**Re: Strategic Housing Development Application to An Bord Pleanála**

**Demolition of existing buildings, construction of 406 no. residential dwellings (281 no. houses and 125 no. apartments/duplexes), childcare facility, 1 no. commercial unit, Public Park, provision of a School Site, and all associated site works. Newcastle South & Ballynakelly, Newcastle, Co. Dublin**

**ABP Reference: 303986-19**

**Figure 1** Proposed Linkages to Existing & Future Development Lands

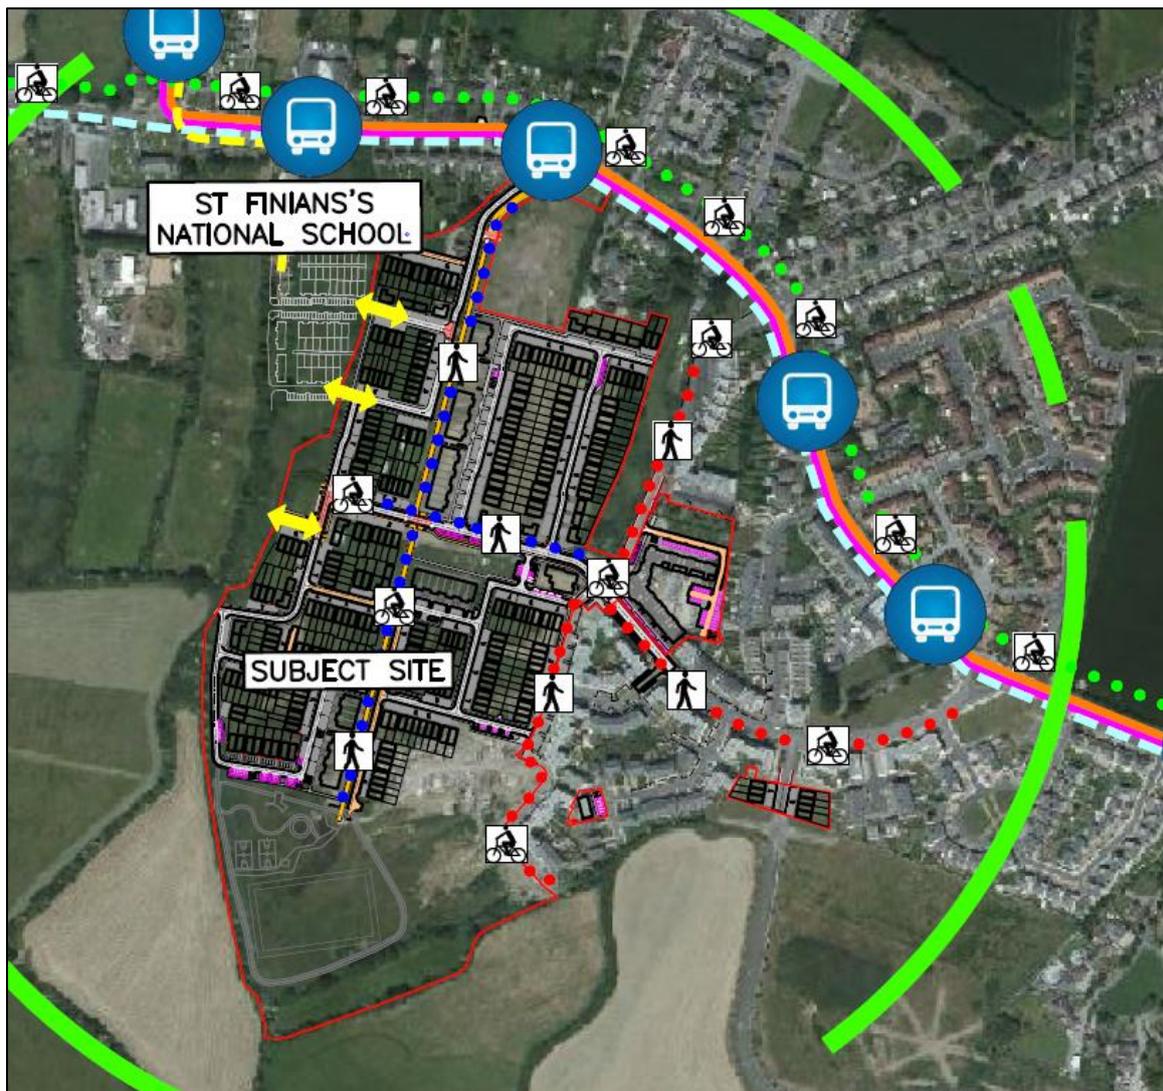
*'Further consideration is required in respect of the documentation relating to the achievement of an acceptable standard of urban design within the proposed development at its integration with existing, permitted and planned development on adjoining land in compliance with the provisions of DMURS, the development plan (including its zoning and roads objectives) and the local area plan (including its indicative layout). The documentation should illustrate how the proposed development would provide suitable street frontage along the main street through the site and along the eastern and southern side of the planned square around the area zoned as open space along the western side boundary, while providing a rectilinear layout of street with perpendicular junctions and omitting the doubling up of parallel carriageways; and showing how links would be provided to the streets in existing and permitted housing on neighbouring lands and how they could be provide to future residential development on the neighbouring lands zoned for such.'*

The provision of linkages from adjacent land to the subject site have been facilitated by providing a road layout that aligns with existing, permitted and future development surrounding the site.

Street links have been provided to the ownership boundary with the development permitted under Reg. Ref. SD17A/0378 to the west of the subject site as shown on DBFL drawing number 170024-2001 & 2002. The proposed road design takes account of the alignment and level of the adjacent development although the final physical connection will be delivered subject to agreement with the

adjoining landowner and South Dublin County Council. These linkages will provide improved permeability to the future development and St. Finian's School.
